**Contractor for the Reconstruction of Taxiway NA
at George Bush Intercontinental Airport Houston (IAH)
CSP No.: H37-RTWYNA-2019-002 PN No.: 9007**

**LOC #4 Attachments
for Clarifications No.'s II through VIII
(revised 11-22-2019)**

LETTER OF CLARIFICATION NO. 4 – 11/18/19

PROJECT NO. 0607
C.I.P. NO. A-000570
H.A.S. NO.
SHEET NO. E08-05

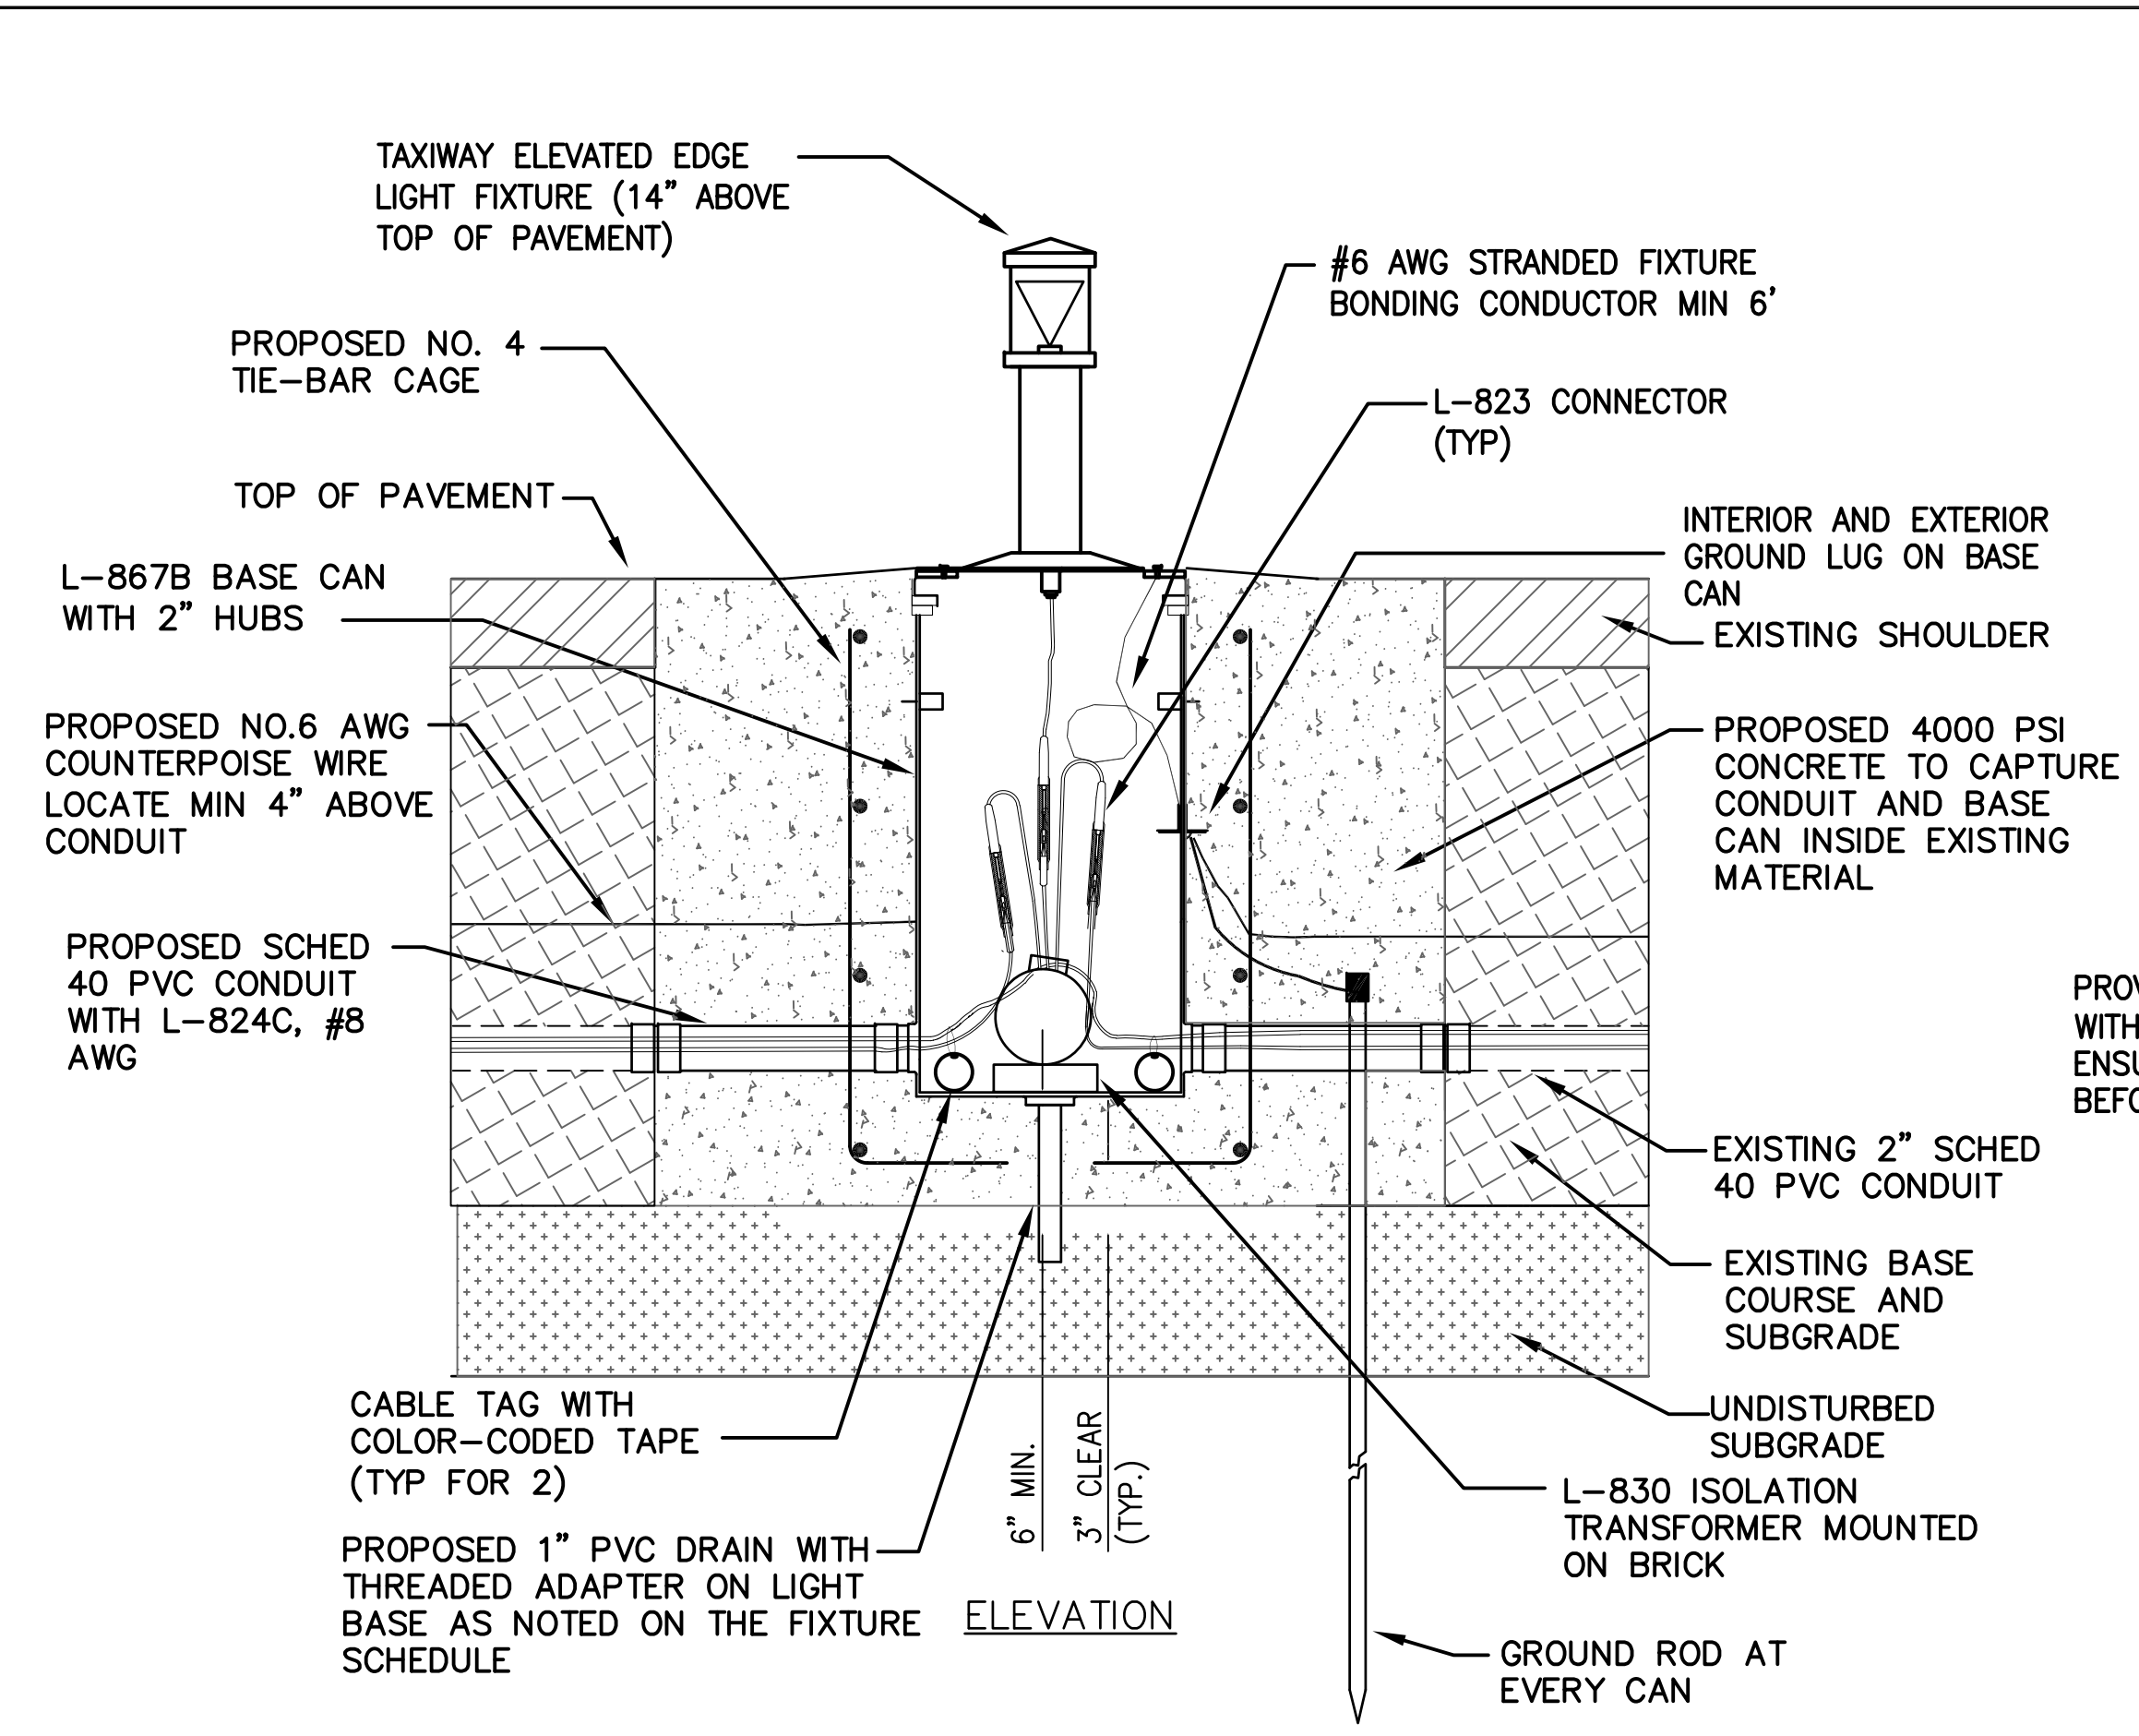
- VI. **Replace plan drawing E08-05 "AIRFIELD LIGHTING LIGHT FIXTURE SCHEDULE TAXIWAY 'NA' CENTERLINE (WEST)"** with new drawing E08-05 "AIRFIELD LIGHTING LIGHT FIXTURE SCHEDULE TAXIWAY 'NA' CENTERLINE (WEST)" showing modification of L-852C fixtures with L-852D fixtures following revised FAA design requirements.

1 LIGHT FIXTURE INSTALLATION AT EXISTING SHOULDER
 E10-03 SCALE: 1" = 1'-0"

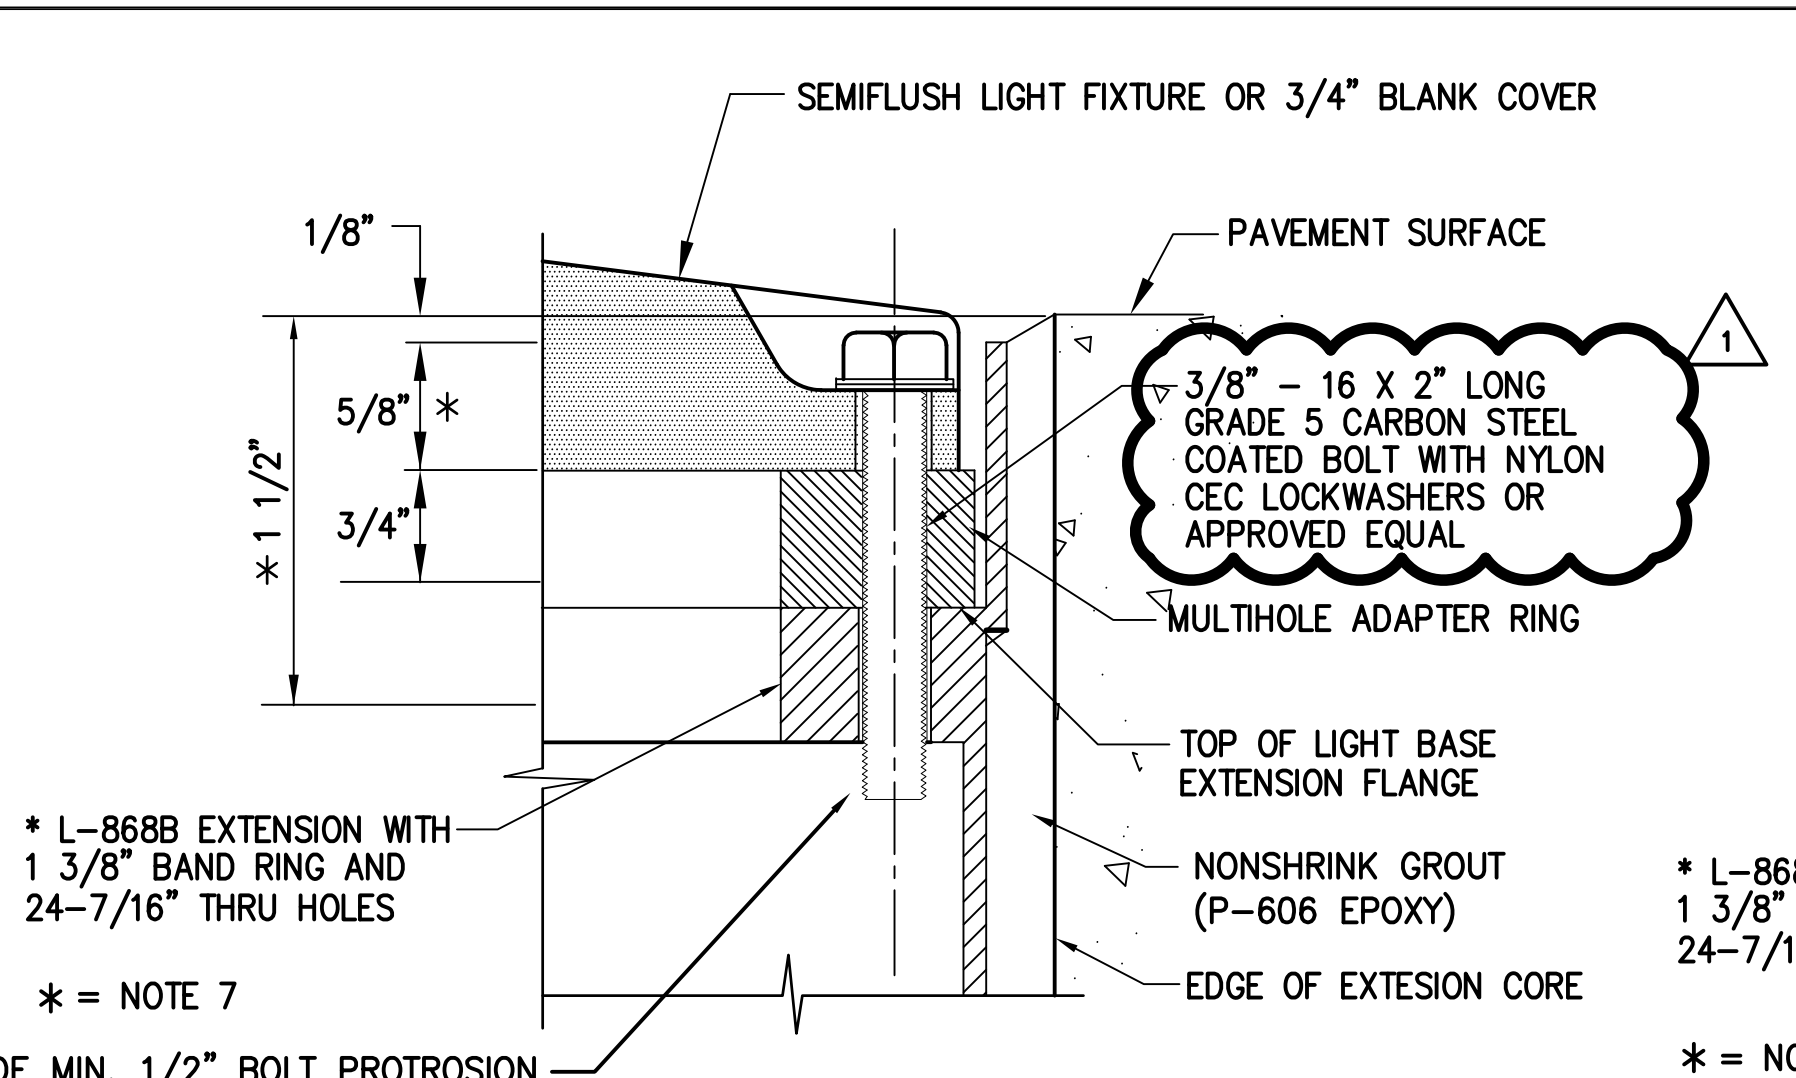
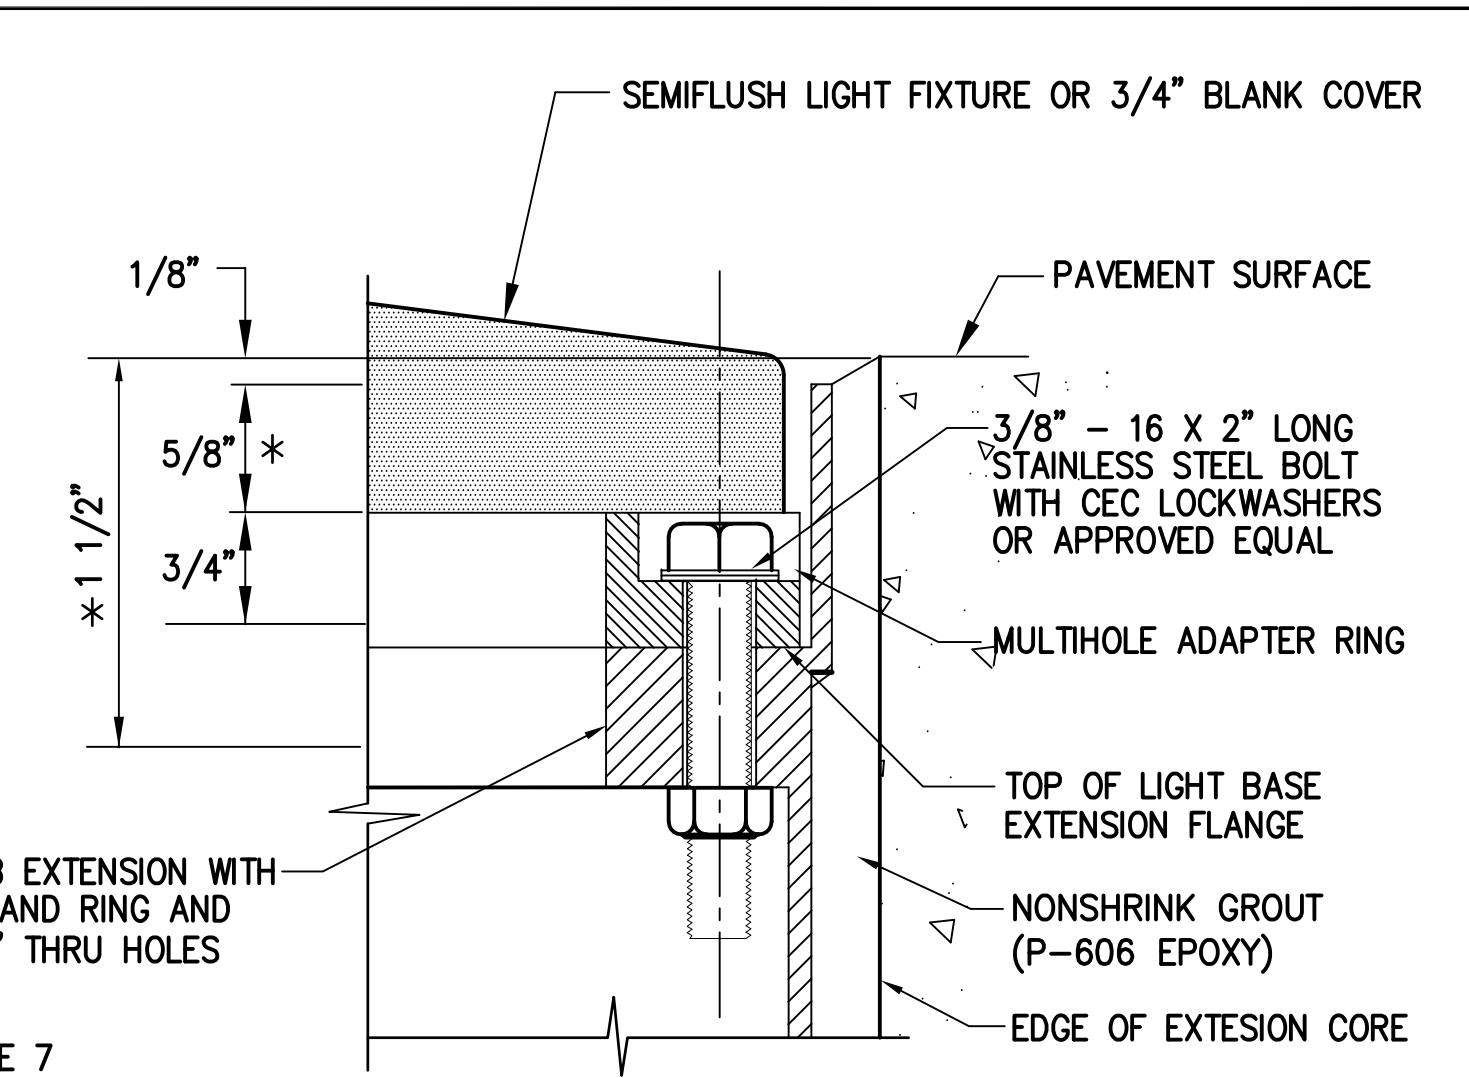
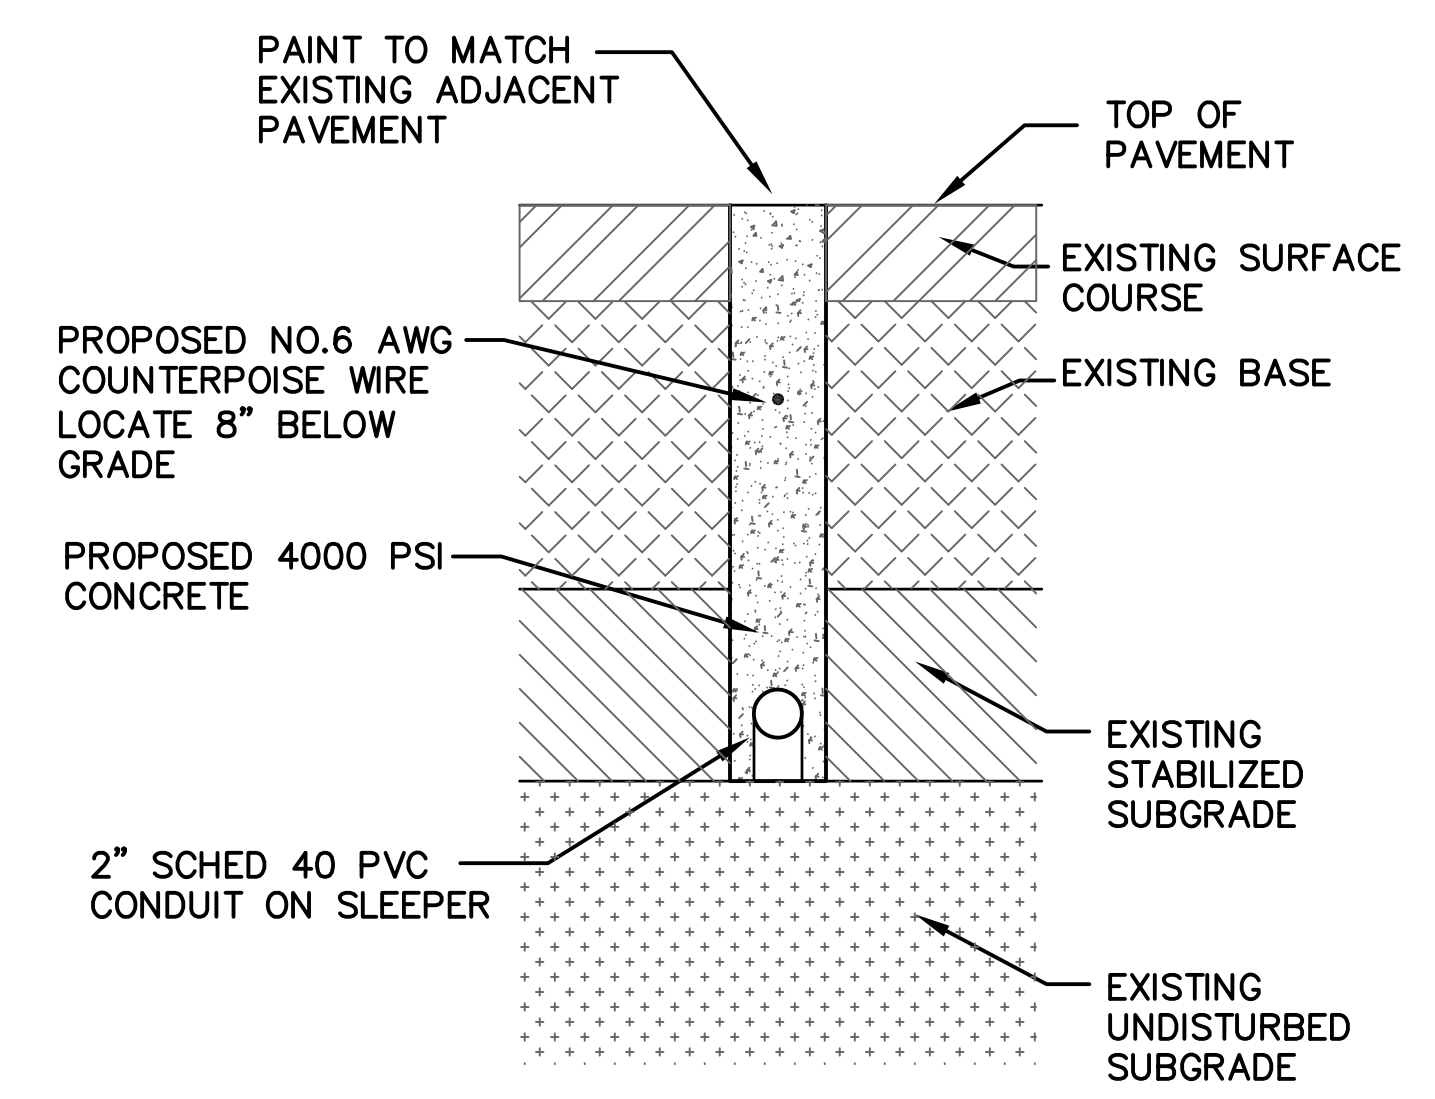
- VII. **Replace plan drawing E10-03 "ELECTRICAL DETAILS AIRFIELD LIGHTING"** with new drawing E10-03 "ELECTRICAL DETAILS AIRFIELD LIGHTING" showing modification to detail 3 modifying bolting hardware to Grade 5 coated bolts.

5. **Do not install anti-seize compound on grade 5 coated bolts.** Bolts shall receive anti-seize compound prior to the final turn.
6. Lock washers shall be installed on each bolt as per fixture base manufacturer's recommendations. Appropriate lock washers are usually provided with bases.

6 PLAN VIEW DETAIL
E10-04 SCALE: NTS

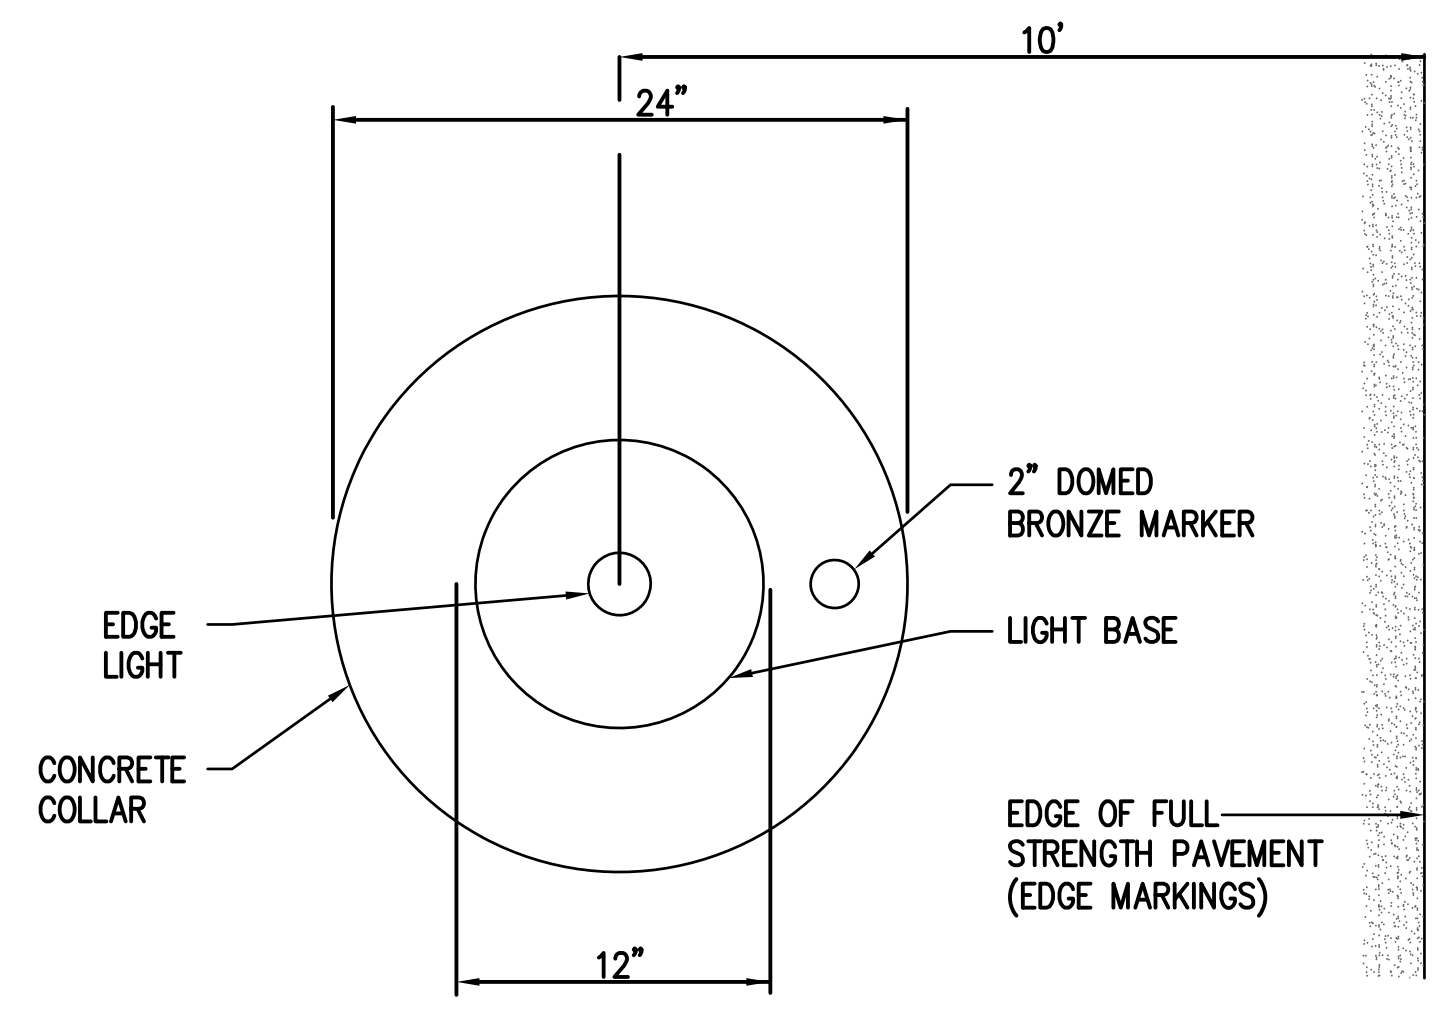
- VIII. **Replace plan drawing E10-04 "ELECTRICAL DETAILS AIRFIELD LIGHTING"** with new drawing E10-04 "ELECTRICAL DETAILS AIRFIELD LIGHTING" showing modification to details 1 and 3 and new detail 6 clarifying label requirements and splice details.

PROVIDE ONE LAYER OF 1.5"W SCOTCH #88 HIGH VOLTAGE RUBBER TAPE HALF LAPPED PLUS ONE LAYER OF 2"W SCOTCH #130C LINERLESS RUBBER TAPE HALF LAPPED, FOR 4 TOTAL THICKNESS AT ANY GIVEN POINT, ACROSS CONNECTOR JOINT. EXTEND A MINIMUM OF 1.5" EITHER SIDE OF CONNECTOR JOINT.
